**City of Portland, Maine – Building or Use Permit Application** 389 Congress Street, 04101, Tel: (207) 874-8703, FAX: 874-8716

DATE: 3 July 2009 ADDRESS: 201 170 MILTON ST. EXT - CBL: 333-E-039  
 REASON FOR PERMIT: To Construct a single family dwelling  
 BUILDING OWNER: Custom Built Homes of Maine  
 PERMIT APPLICANT: \_\_\_\_\_ / CONTRACTOR SAO  
 USE GROUP: R-3 CONSTRUCTION TYPE: 5-B CONSTRUCTION COST: 280,000 PERMIT FEES: 504.00

CITY OF PORTLAND, ME  
BOCA 1999 Plan Review Record  
One and Two Family Dwelling

Building Description: Single Family Dwelling

Job R46511	Truss C	Truss Type ROOF TRUSS	Qty 4	Ply 1	(optional)	Y1378934
---------------	------------	--------------------------	----------	----------	------------	----------

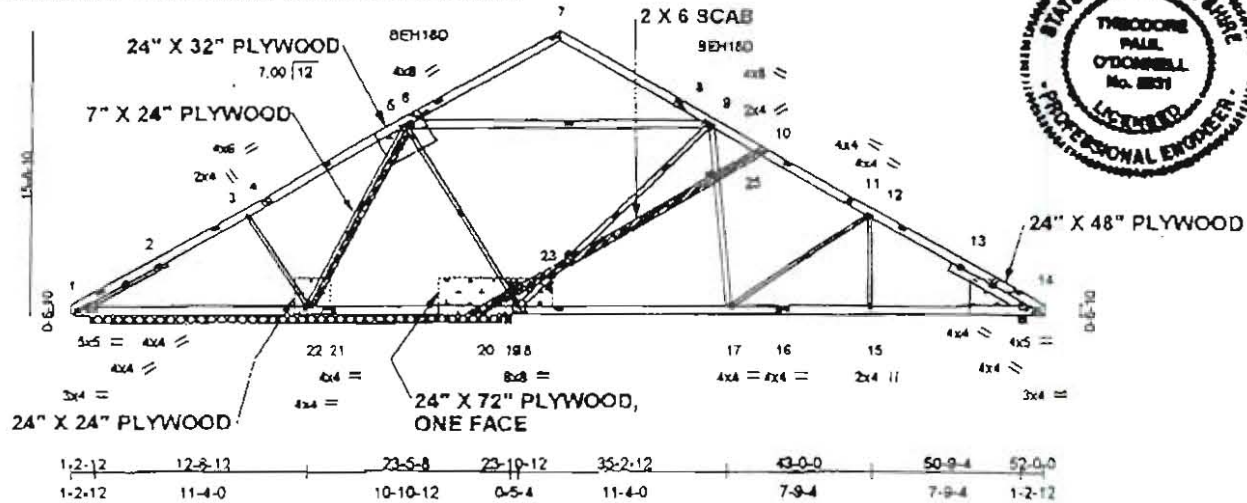
10-12-2K: Questioned Trusses for Wdg. Noted ~~top~~ over front door, brace between trusses, cut at trim where trim meets next left side of Wdg. ? Scabbly trim used over living room - Wdg to ground, ? spec sheets for chimney & Appliances. OK

11-1-2K: Visited site w/ S.B. to check connection over front door; trim room rebound Gary Ruel to info from Trussing was insufficient & we would more specific Data. Could not see Header @ Front Door, Contractor agreed to open front wall sheathing, & will call, Basement stairs not compliant - Contractor to make corrections. OK w/ S.B.

12-8-2K: Contractor had removed floating @ Front entry exposing 2x4 under Header supporting Truss over front door, other

CONDITION: REINFORCE THE TRUSS FOR BEARINGS AS SHOWN. INSERT NEW WEB & ATTACH PLYWOOD. ATTACH SCAB WITH MIN. 4 -12d NAILS AT EACH INTERSECTION.

ADD NEW MEMBER(S) AS SHOWN HATCHED. SEE LUMBER SPECIFICATIONS SECTION FOR PROPER SIZE AND GRADE. USE 2 x 4 #2 MIN.

To clarify my letter of October 26, 2000, regarding the roof trusses on lot 170, Milton Street, Portland, Maine. The field repair drawing we furnished to Custom Built Homes of Maine addresses the actual conditions of the truss in question as installed ie:

- The bearing on one side of the truss is elongated because the truss actually bears on an exterior wall transferring loads through that wall to the foundation.
- The intermediate bearing shown on the original truss drawing has been eliminated.
- Live and dead loads from the adjacent shorter span truss have now been accounted for.

Please refer to the field repair drawing which clearly states all design loads, lists the load cases and shows the bearing locations as they exist. If you have any questions, please call.
